STAGE/STATUS  
DA SUBMISSION  
DRAWING TITLE  
BREWHOUSE CARWASH LAYOUT  
DRAWING NO. ISSUE DATE DRAWN  
A2.101 B 05 MAR 20 BHG

Re: DA 2021/0004  
Car Wash  
160 North Street, Grafton NSW 2460  
Lot 13 DP 1120659  
DCS Building & Consulting

**SECTION 4.15 EVALUATION FOR DA2021/0004**  
**- Lot 13 DP 1120659- 160 North Street GRAFTON NSW 2460**

**Additional Information Requested – DA2021/0004 – Reply.**

STAGE/STATUS  
DA SUBMISSION  
DRAWING TITLE  
LANDSCAPING LAYOUT & SCHEDULE  
DRAWING NO. ISSUE DATE DRAWN  
A6.101 B 05 MAR 21 BHG

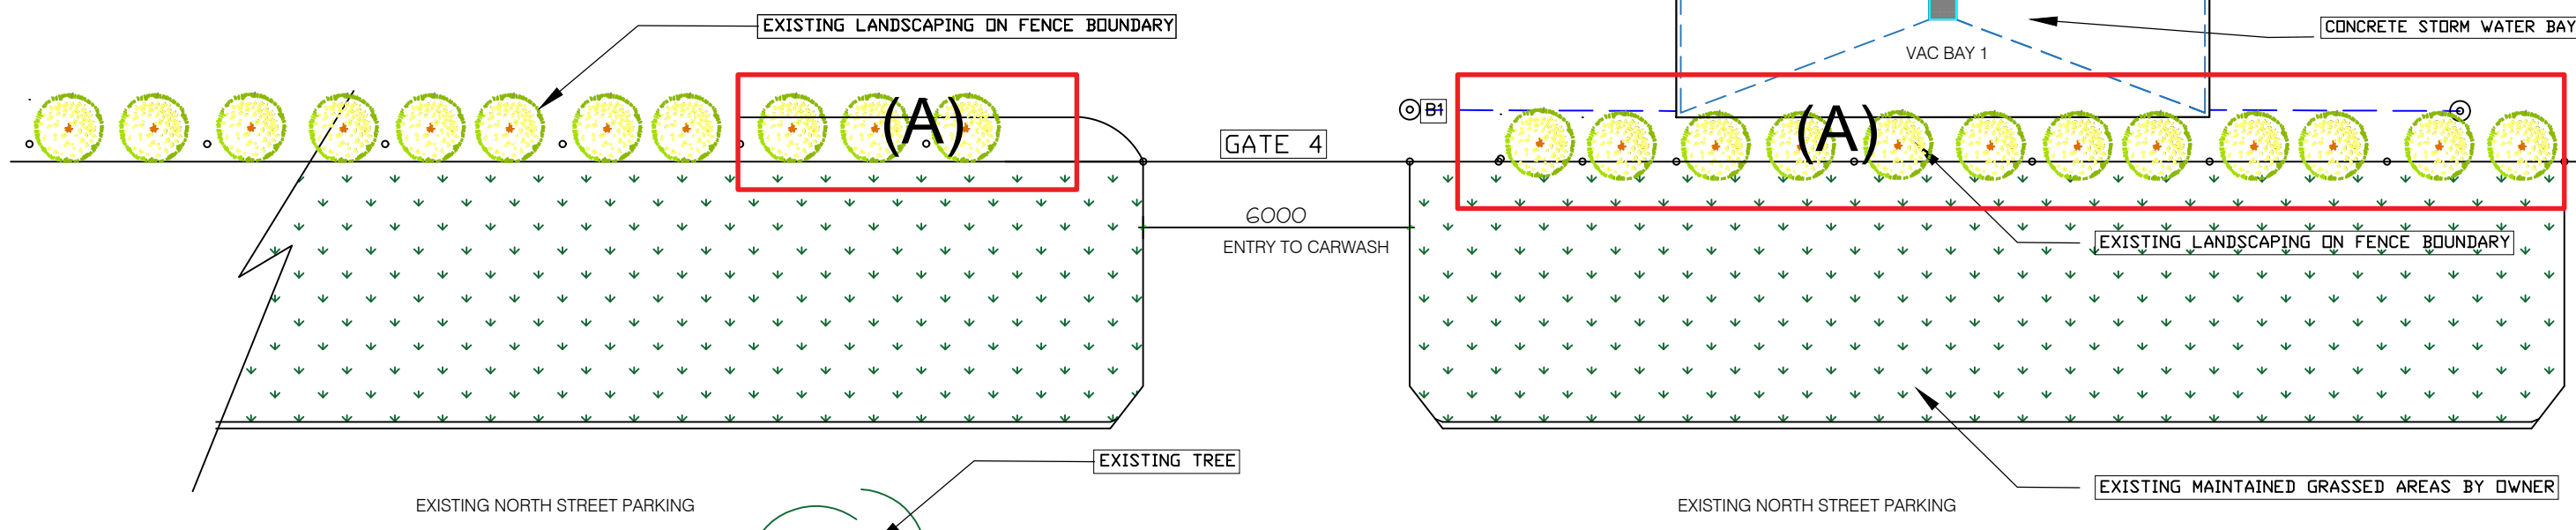
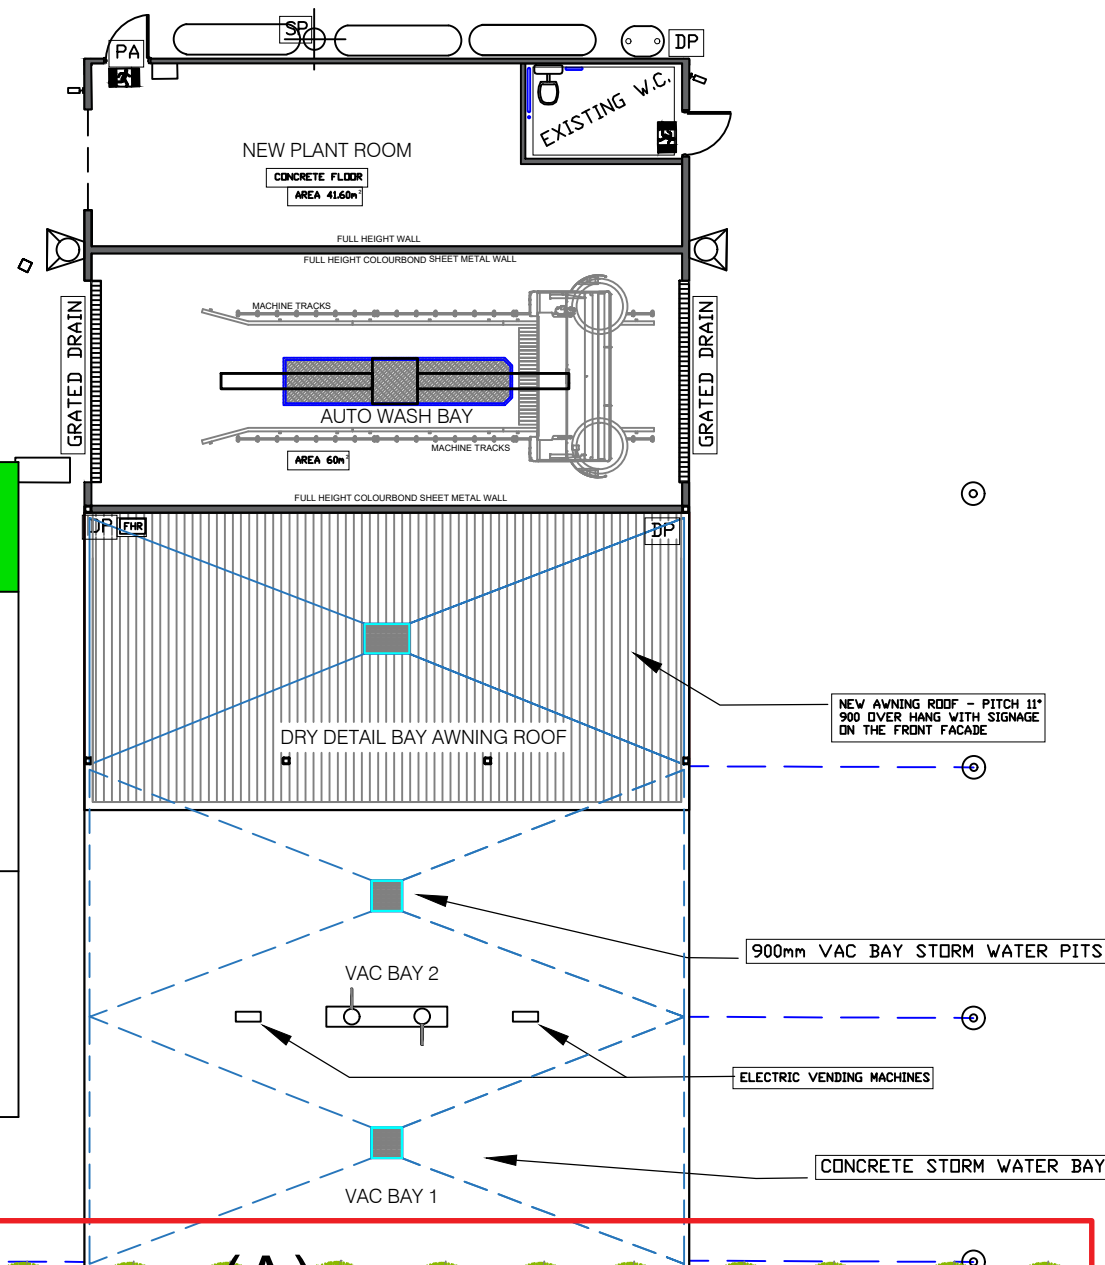
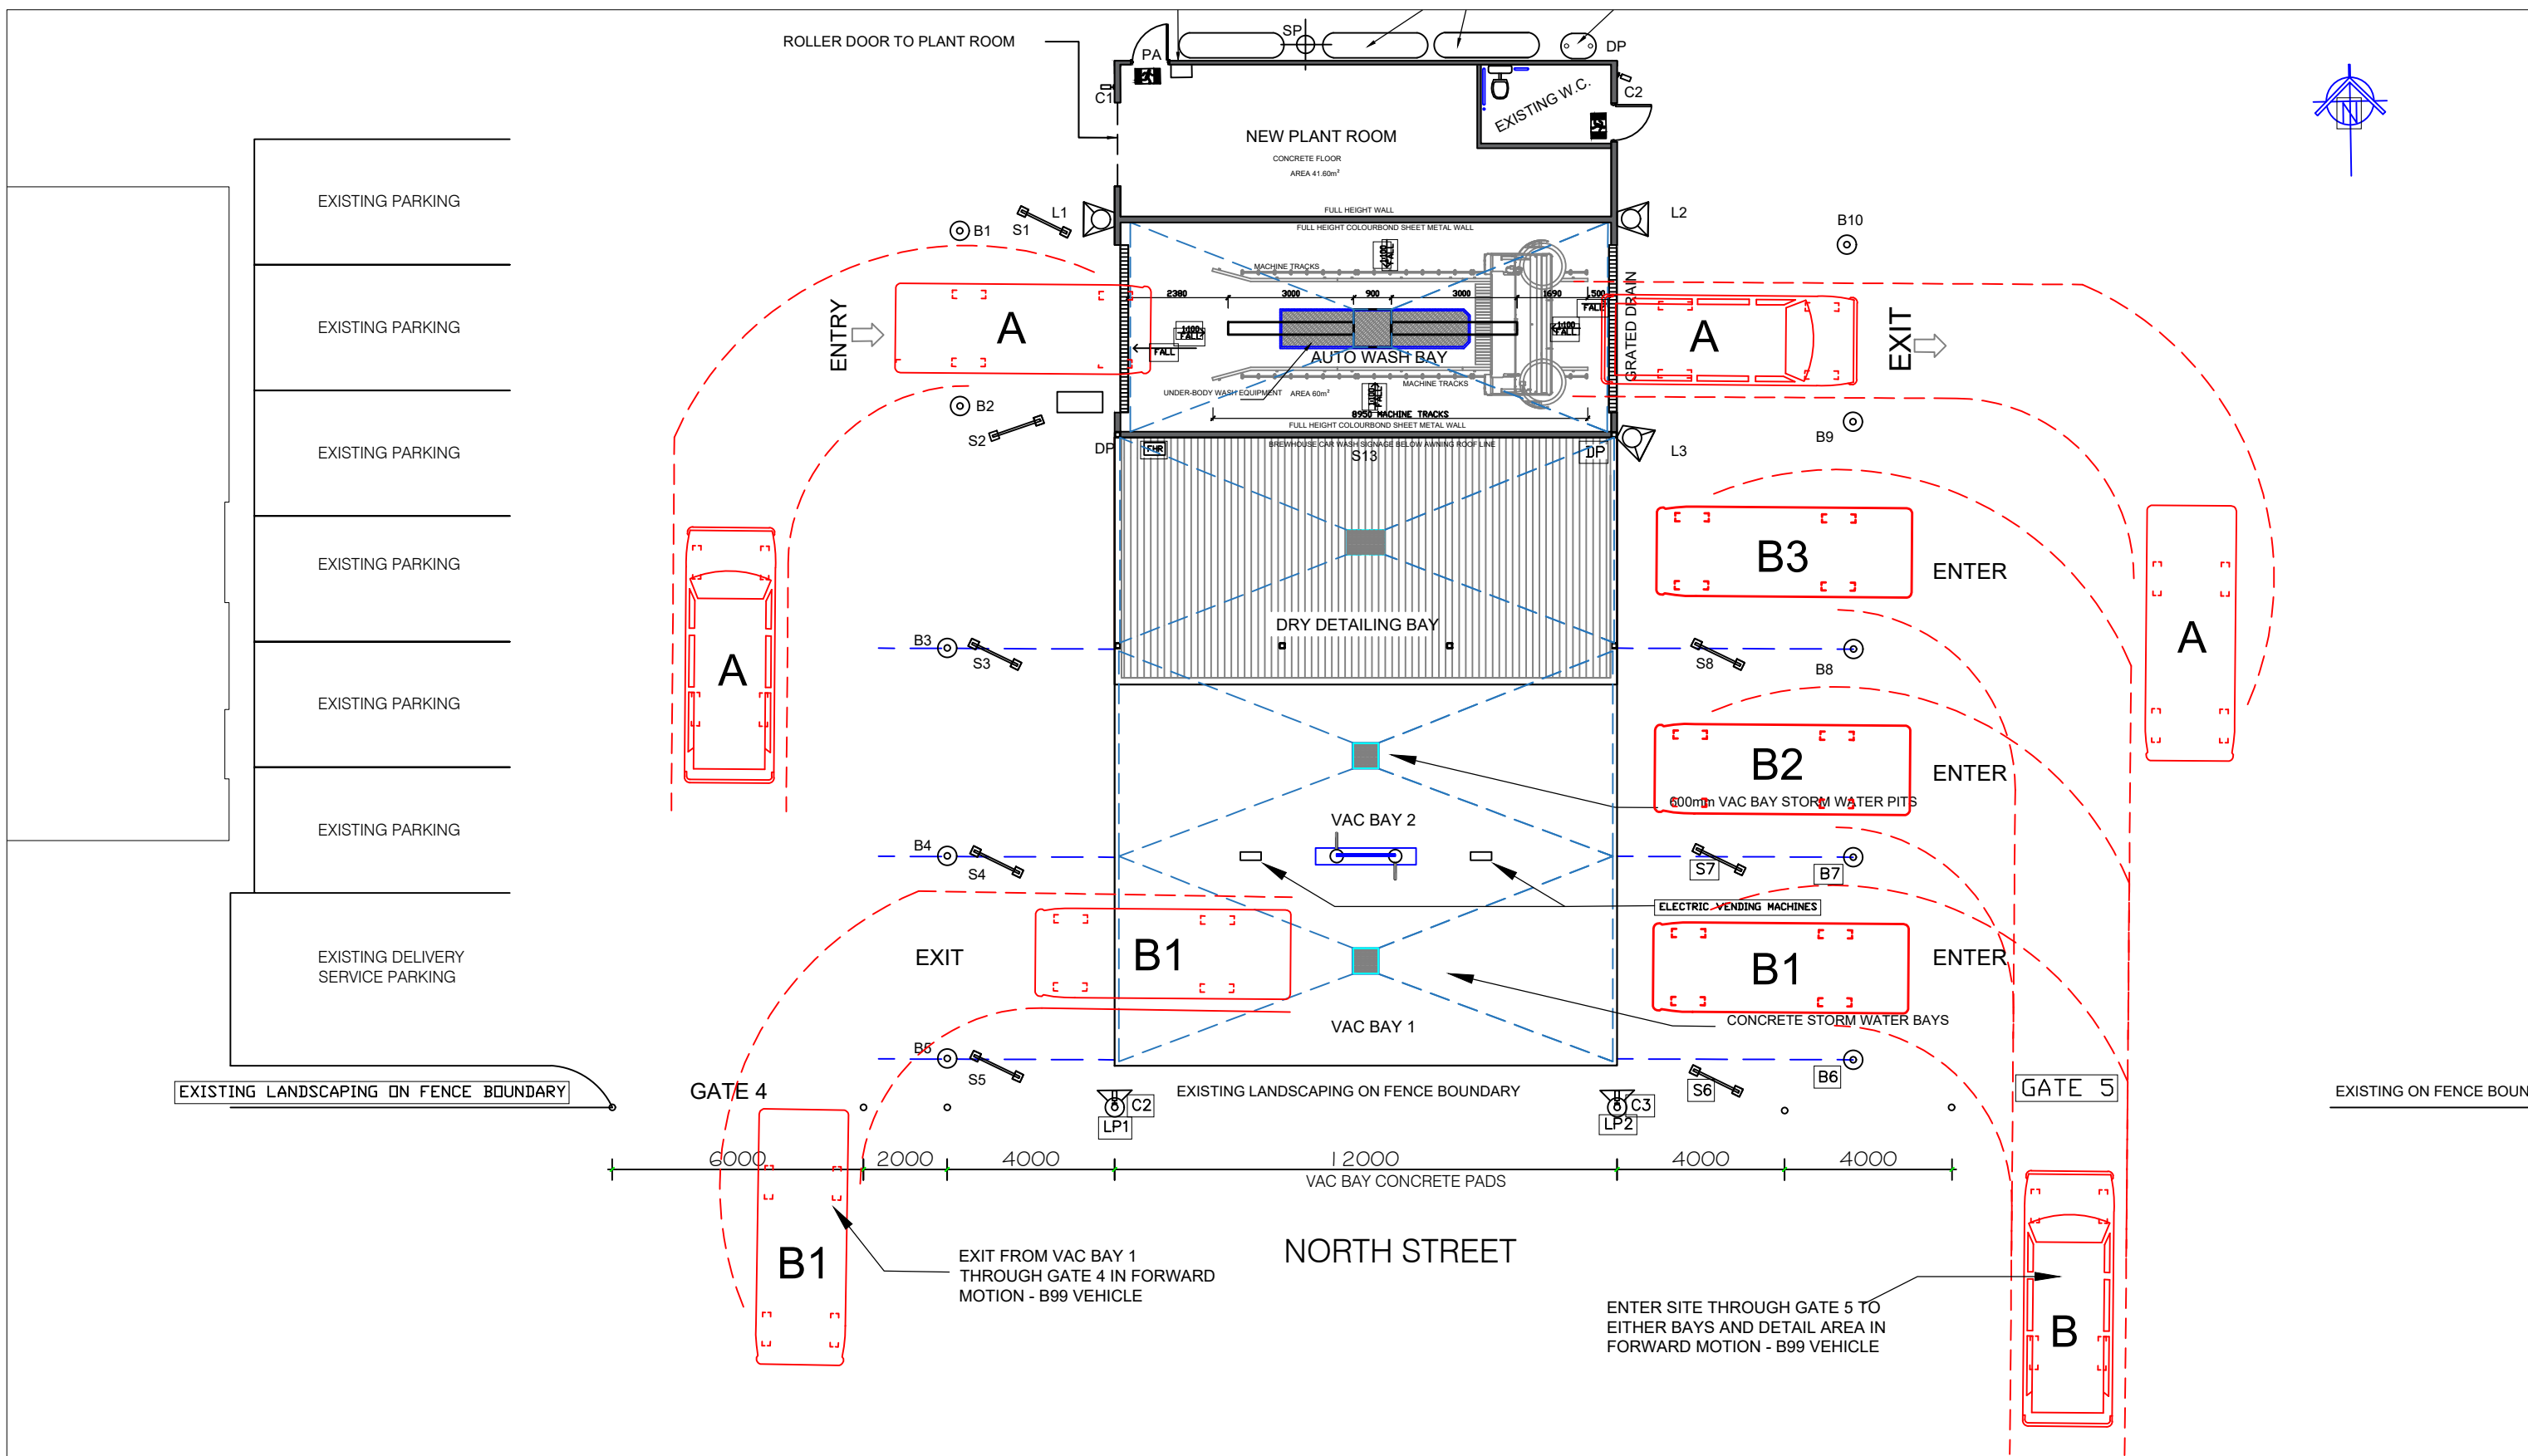
**Item 4.** Reference to amended Landscape Plan A6 101 B dated 21<sup>st</sup> Feb 2021.

The plan was missing the schedule. The amended plan now has this schedule and complies with the CVCDPC Part C8.6 provisions. The owner would like to highlight that the previous tenant had not maintained the vegetation along the fence line. And that there were plants previously grown on the fence boundary and where removed. The owner is happy to provide further maintenance along the fence line and provide a hedge along the fence line within the boundary. Grass will remain on the verge and be maintained by the Owner.

STAGE/STATUS  
 DA SUBMISSION  
 DRAWING TITLE  
 VEHICLE MANOEUVERING LAYOUT  
 DRAWING NO. ISSUE DATE DRAWN  
 A7.101 B 05 MAR 20 BHG

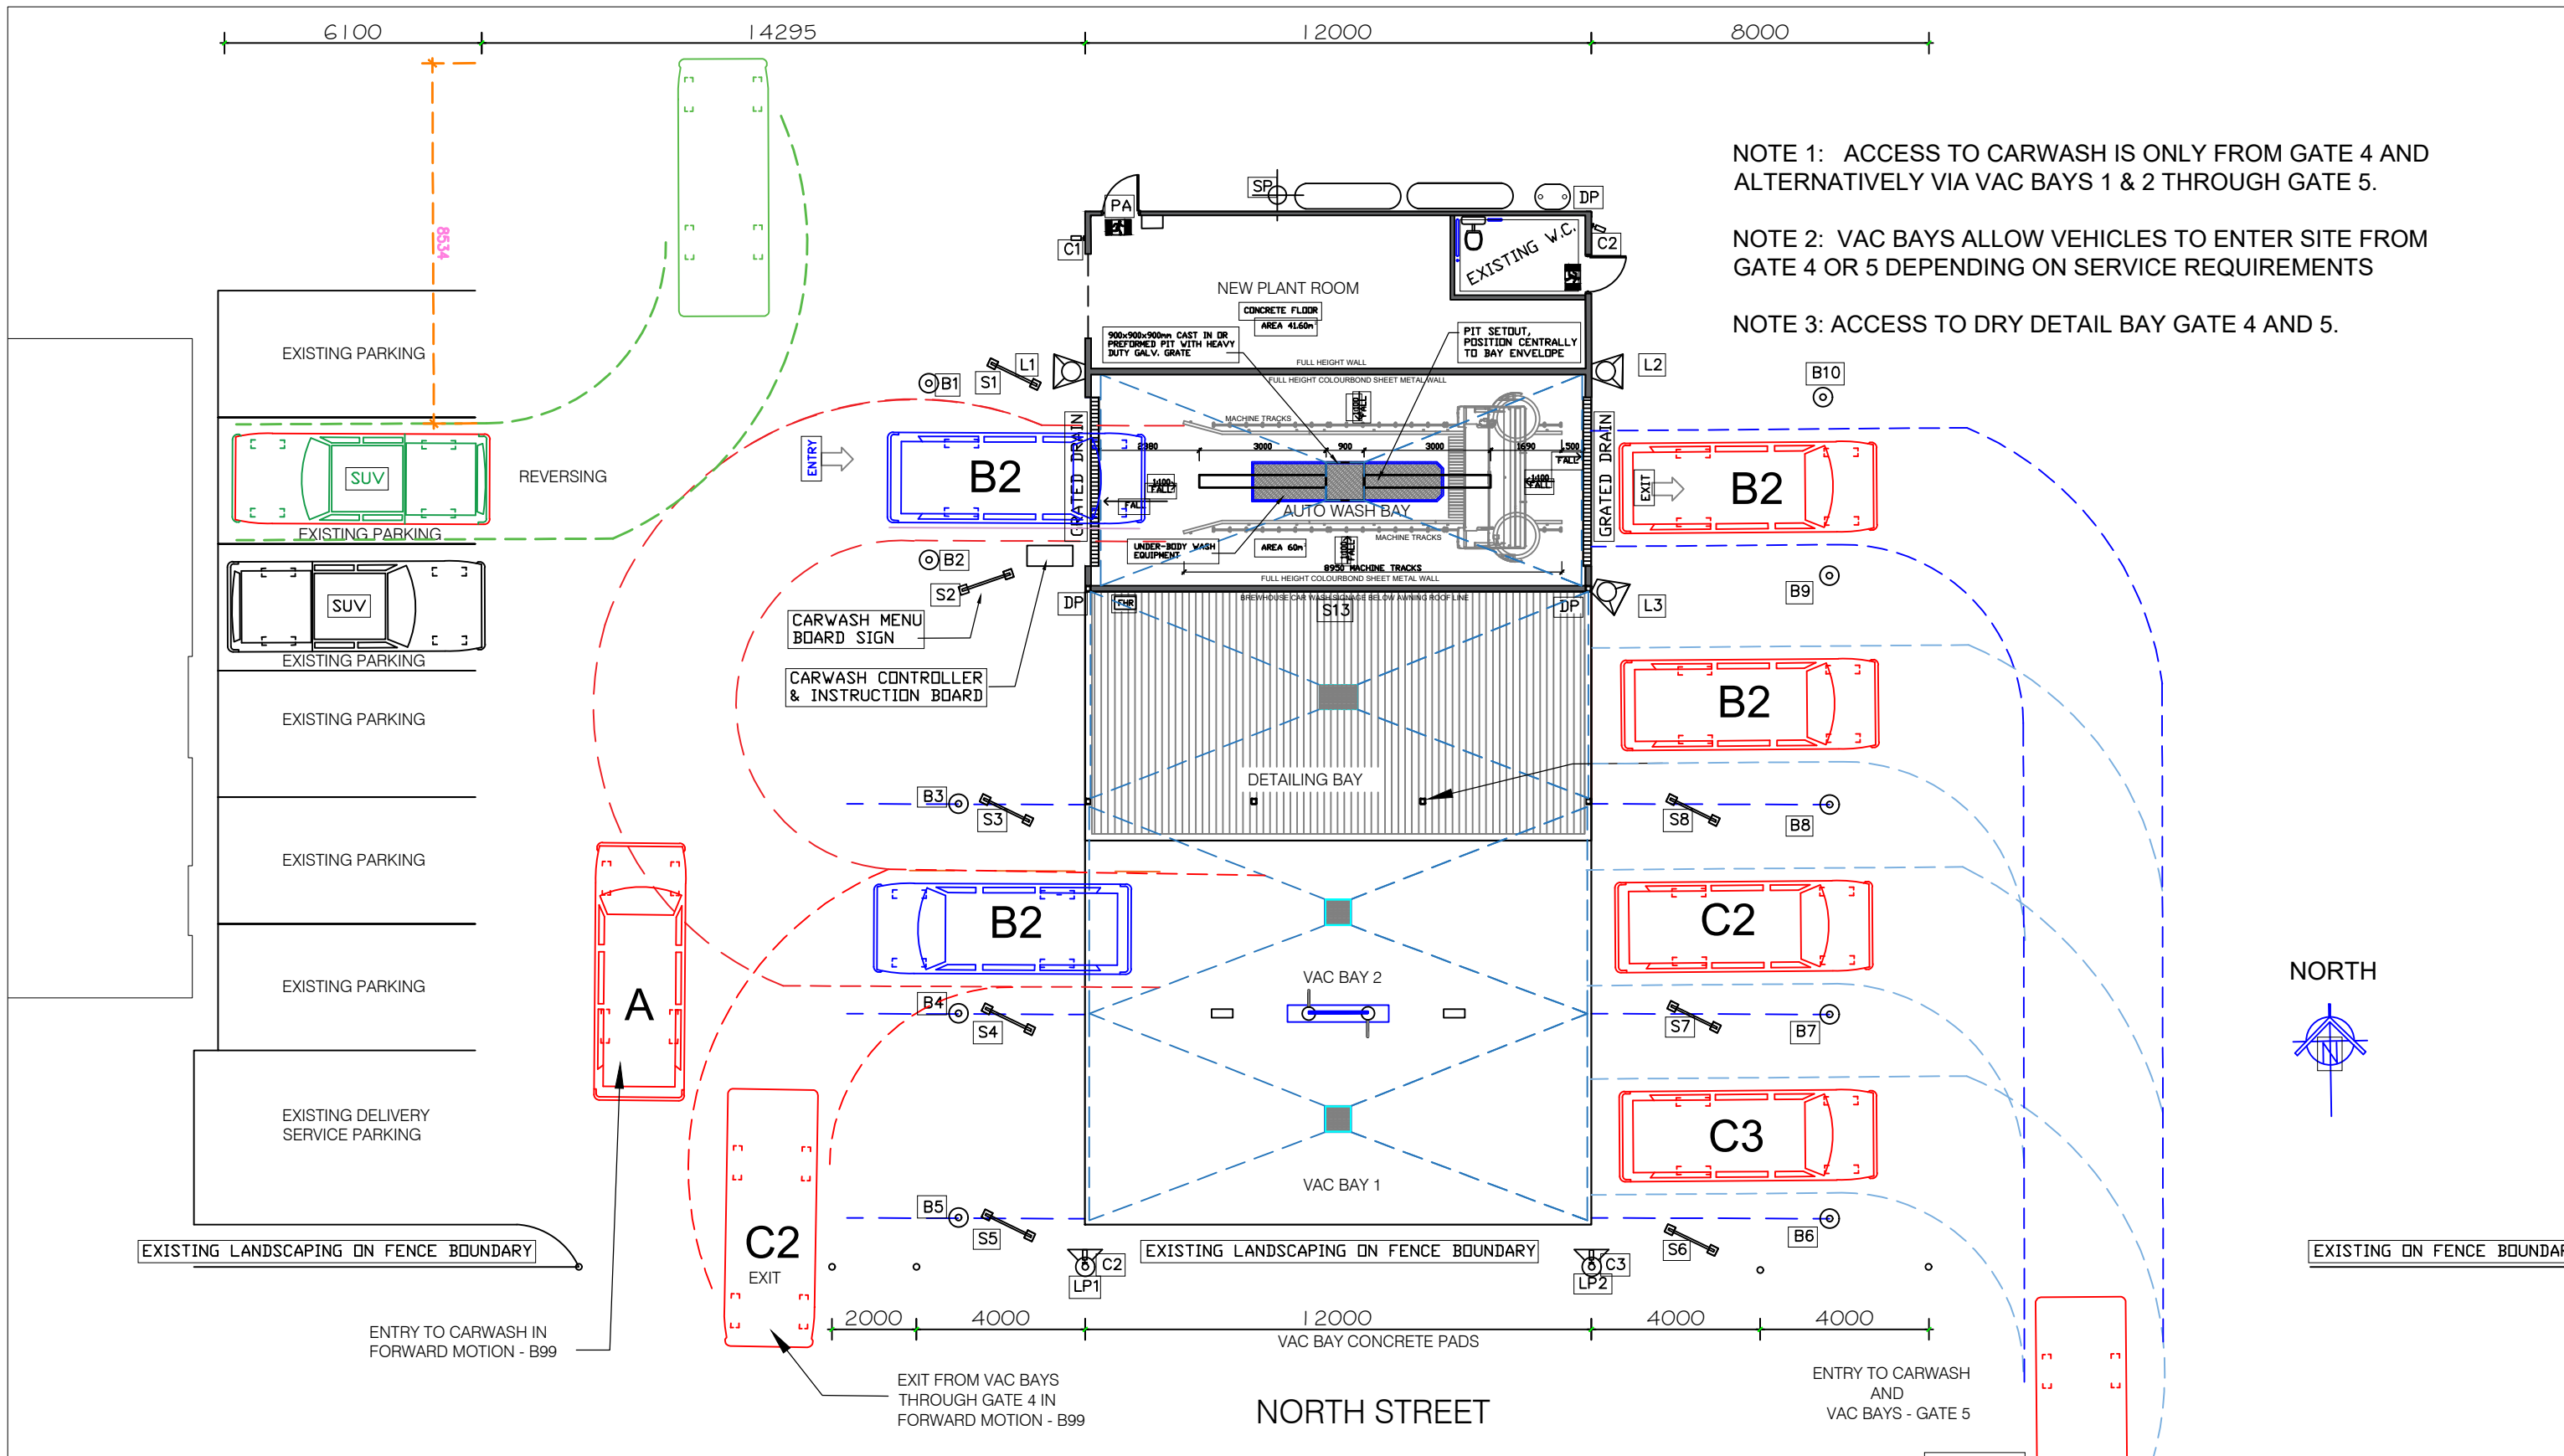
**Item 2.** The owner is expecting 2-3 cars per hour on average to use the Carwash facilities. The impact on Cueing has seriously been reduced as a result of relocating the Return and Earn and that this Development proposal will minimise cueing to onsite 99% as per DCS drawing A7 101 & a7 102 indicates.
